MAG Standard Specifications and Details Committee
TENTATIVE AGENDA
February 3, 2016

MEETING MINUTES FROM THE
MARICOPA ASSOCIATION OF GOVERNMENTS
STANDARD SPECIFICATIONS AND DETAILS COMMITTEE

2015 PROPOSED REVISIONS TO MAG SPECIFICATIONS AND DETAILS

DETAIL NO.
270-2

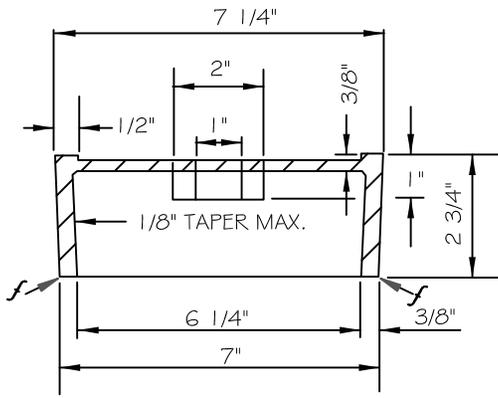
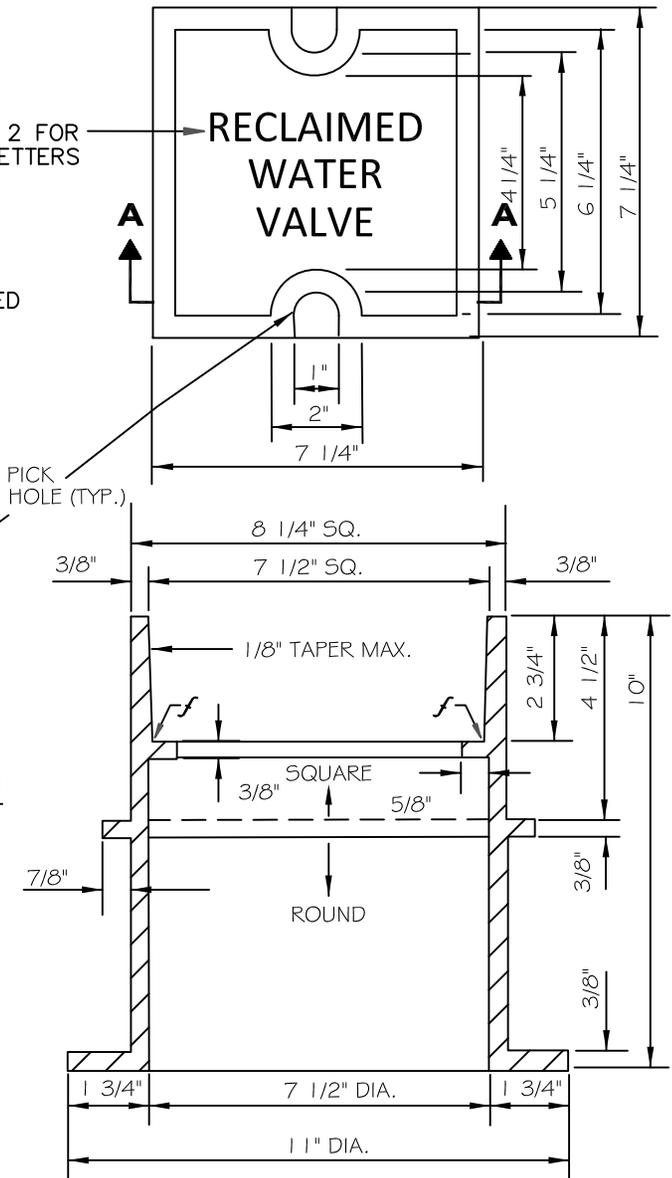
Warren White handed out an updated version of the case at the meeting. He said the purpose of the case was to provide a square frame option, which is shown in the revised Detail 270-2. Asterisks were placed next to the new changes which included the title revision, and the option to have the cover marked "NONPOTABLE WATER VALVE" as an alternative to "RECLAIMED WATER VALVE." The longer alternate title required the lettering to be ½"

rather than $\frac{3}{4}$ " high. Mr. Herz asked about the width of the lettering. Mr. White said he was unsure of the exact width, only that it was based on the CAD font fitting the space allowed. He said Detail 270 would become 270-1 and the title changed to add "ROUND" before the frame and cover text. It was also thought that the lettering should be noted as raised $\frac{1}{16}$ " to match Detail 270-1. Lance Webb asked if the lid should be deeper, such as the round one in 270-1. Mr. White said he didn't think it was necessary, because the square shape made it less likely to rattle and pop out.

Paul Nebeker asked if Nenah Foundry had been contacted. Mr. White said they sent sample detail drawings that were used in developing the draft detail. Mr. Herz asked if the detail should show the round to square transition. Mr. White said that although the details from Nenah were shown this way, the draft detail, and boxes he has seen, go directly from round to a square box sitting on top of it. Paul Nebeker agreed that this was similar to what he saw in the field.

Purpose: Incorporate a square frame and cover intended for reclaimed water valve construction meeting ADEQ requirements (option to colored purple)

- New “SQUARE FRAME AND COVER AND GRADE ADJUSTMENT” Detail 270-2.
- Revise current Detail 270, FRAME AND COVER to “ROUND FRAME AND COVER” and revise detail number to 270-1.
- Revise Section 616 Reclaimed Water Line Construction as follows:

1. CASTING TO CONFORM TO SECT. 787.
2. LETTERS ON COVER TO BE AS FOLLOWS, PER AGENCY REQUIREMENTS:
3/4" HIGH "RECLAIMED WATER VALVE" OR 1/2" HIGH "NONPOTABLE WATER VALVE".
LETTERS TO BE RAISED 1/16". TYPE OF LETTERS TO BE SUBMITTED FOR APPROVAL.
3. *f* INDICATES MACHINE FINISHED SURFACE.
4. VALVE BOX SHALL HAVE A ROUND BOTTOM TO ACCOMMODATE RISER PIPE.

**ENCASED CONCRETE PIPE
(FOR SHALLOW INSTALLATION)**

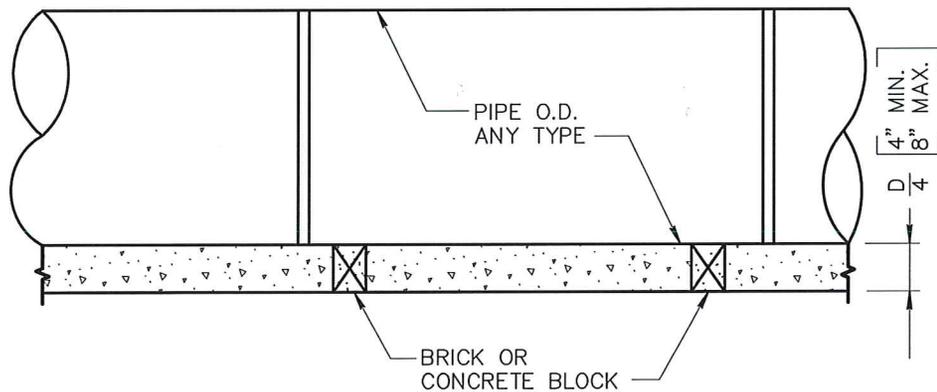
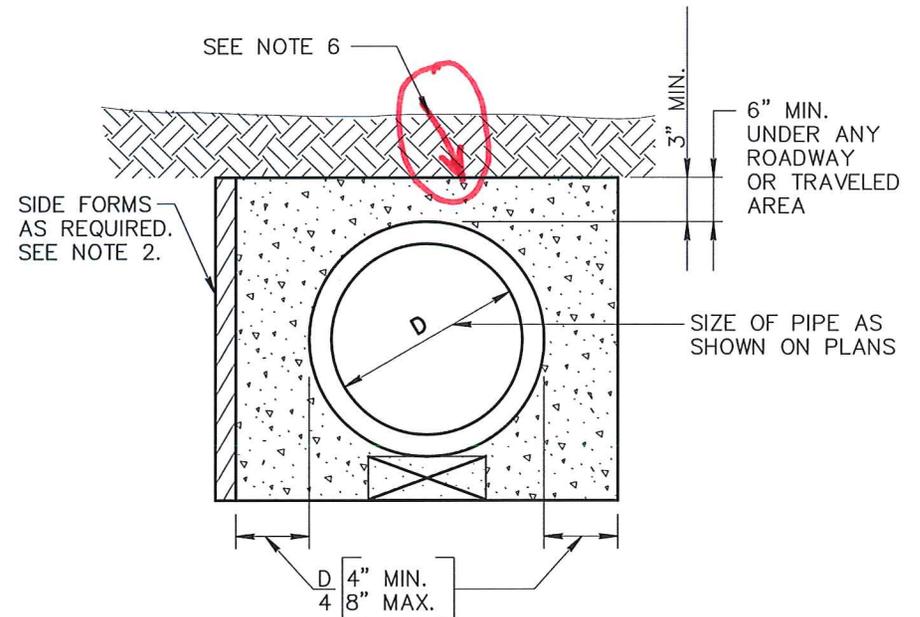
CASE 16-01 B

Subject: Revision to Detail 251 RETURN TYPE DRIVEWAYS

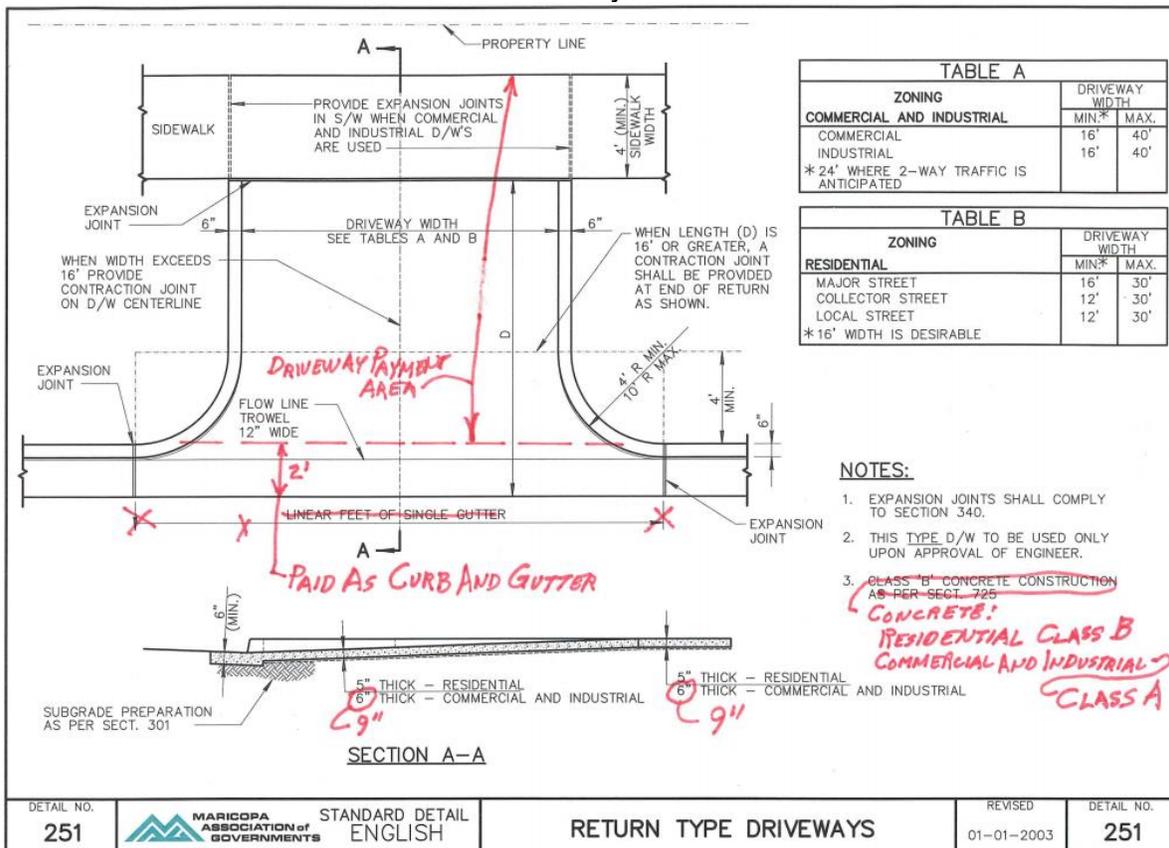
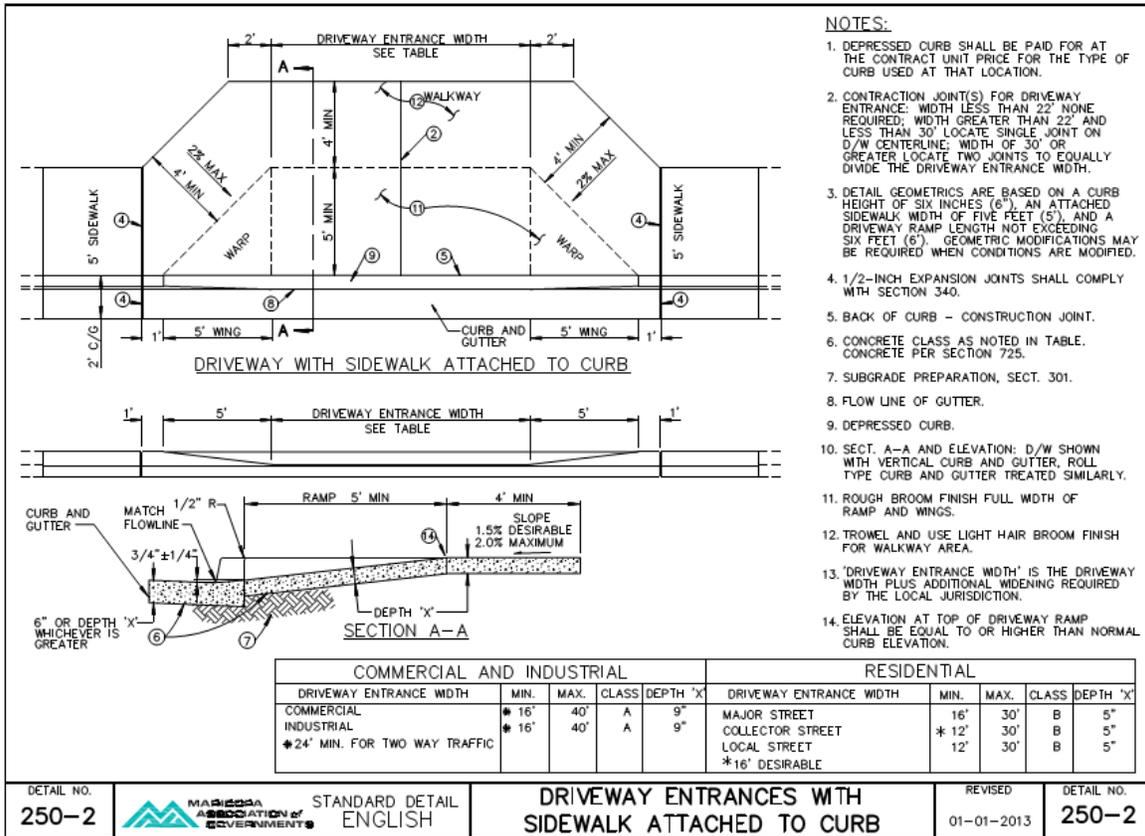
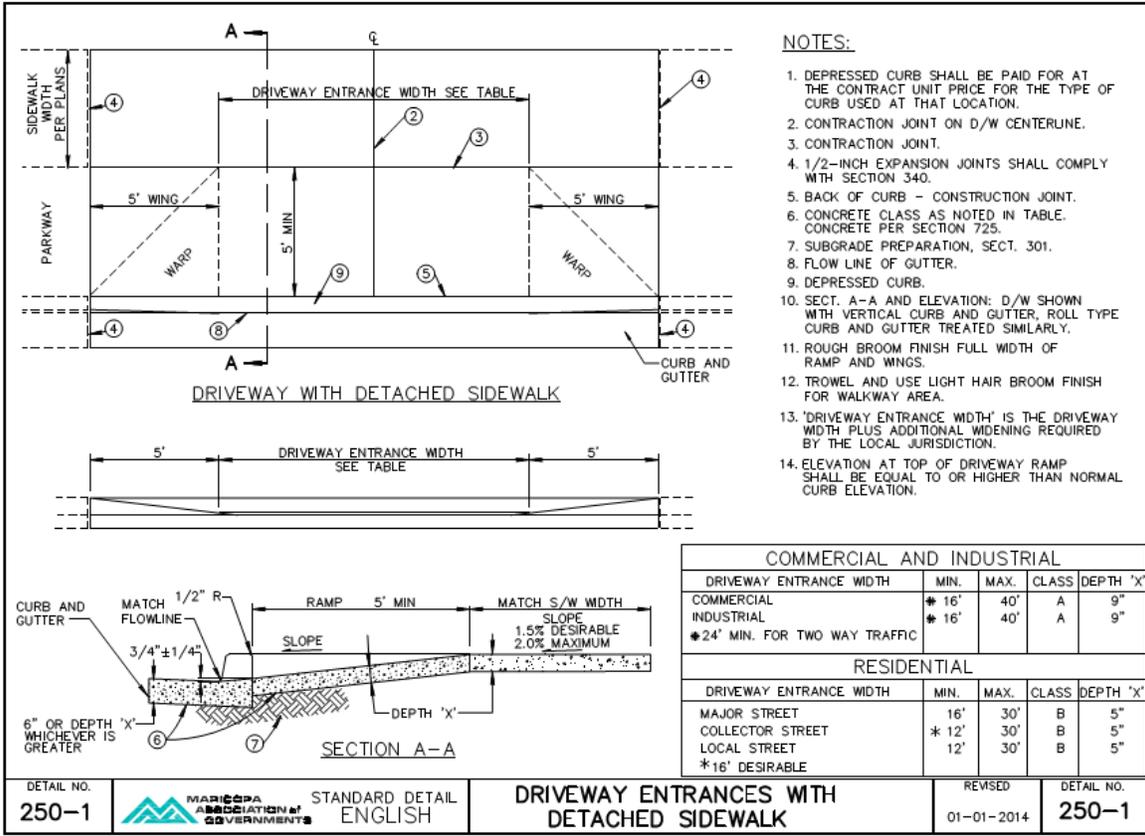
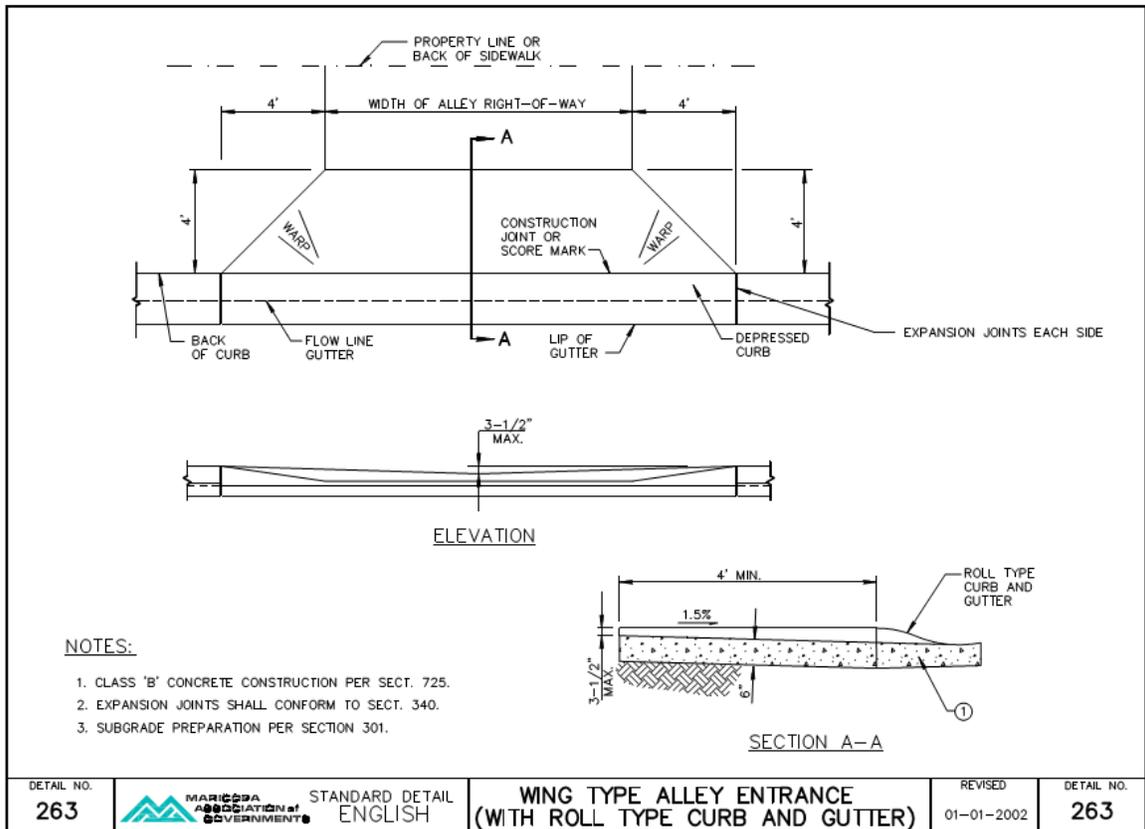
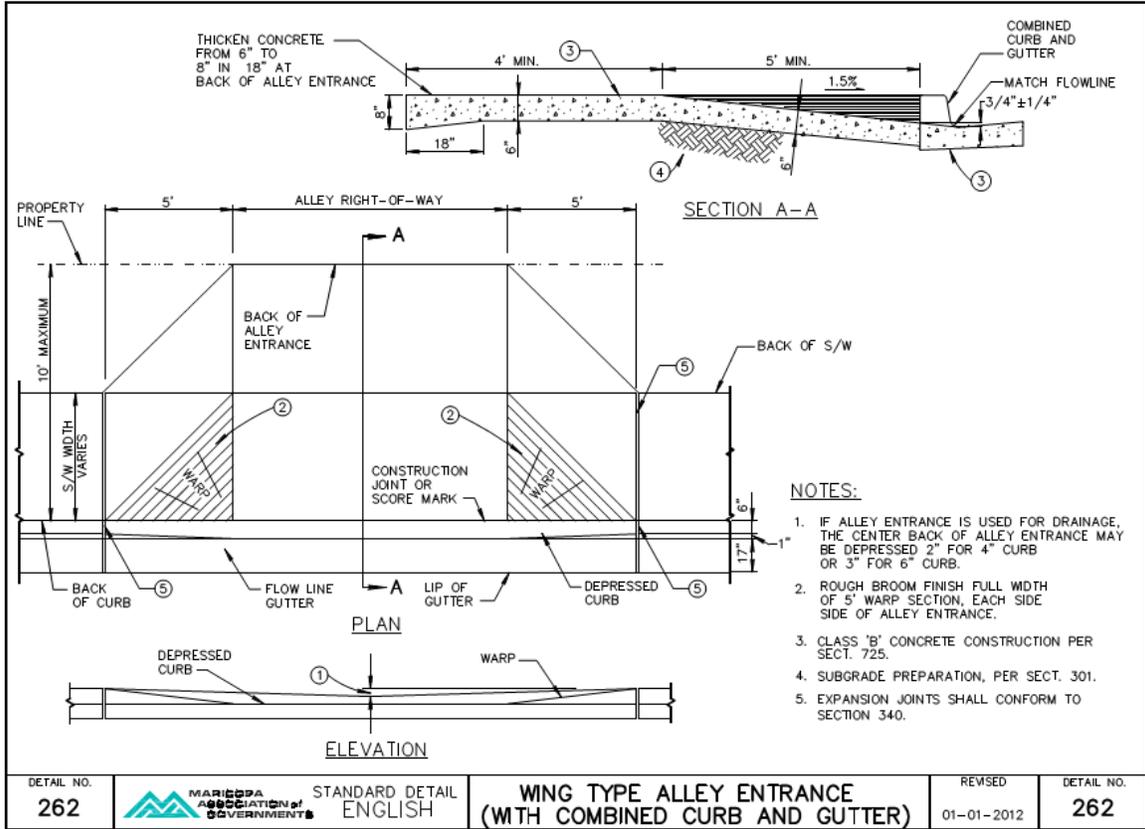
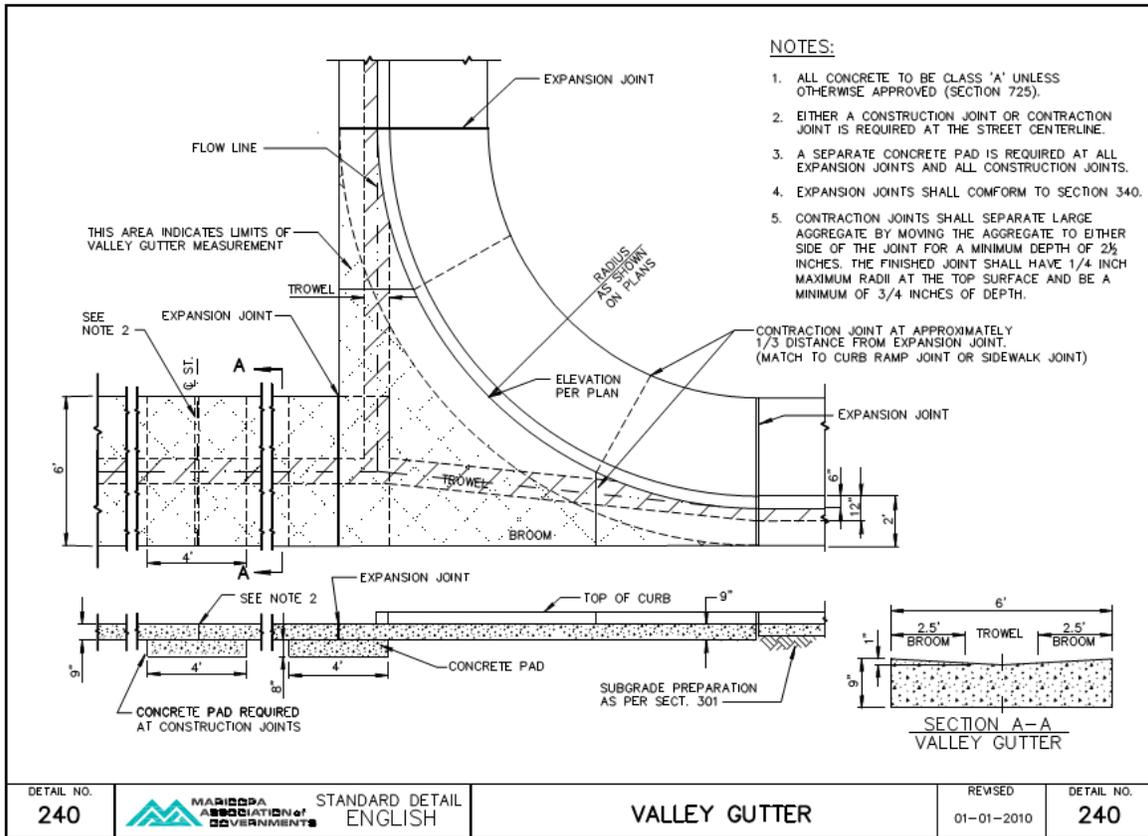
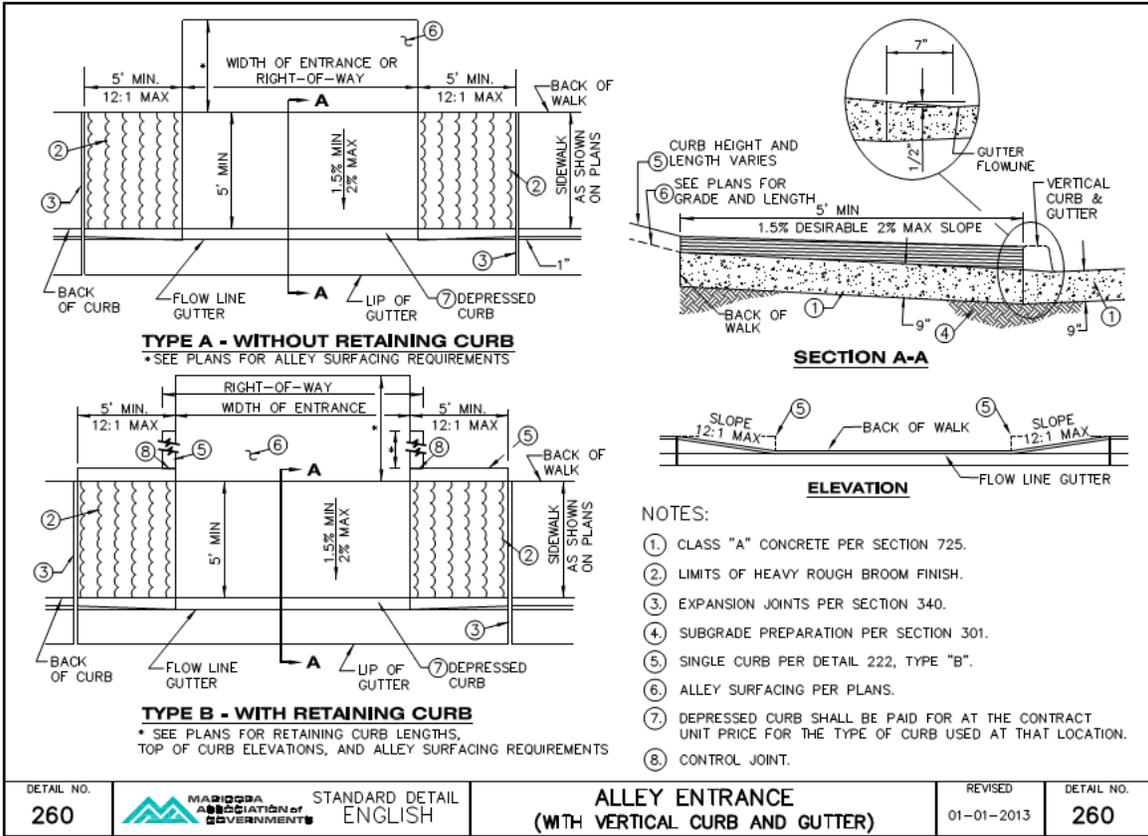
Bob Herz introduced a new case with revisions to Detail 251 that would change the concrete thickness from 6” to 9” for commercial and industrial driveways, change the concrete from Class B to Class A for commercial and industrial driveways, and clarify payment limits for curb & gutter and for the driveway. He said this thickness would also match the apron on valley gutters.

PURPOSE: Adjust concrete thickness and concrete class for commercial and industrial driveways to match requirements shown on Detail 250.

REVISIONS: Change concrete thickness from 6" to 9" for commercial and industrial driveways. Change concrete from Class B to Class A for commercial and industrial driveways. Clarify payment limits for curb & gutter and for the driveway.

QUESTIONS: Should the same changes be made to alley entrances Details 262 and 263? Should residential driveways be deleted from Detail 251?
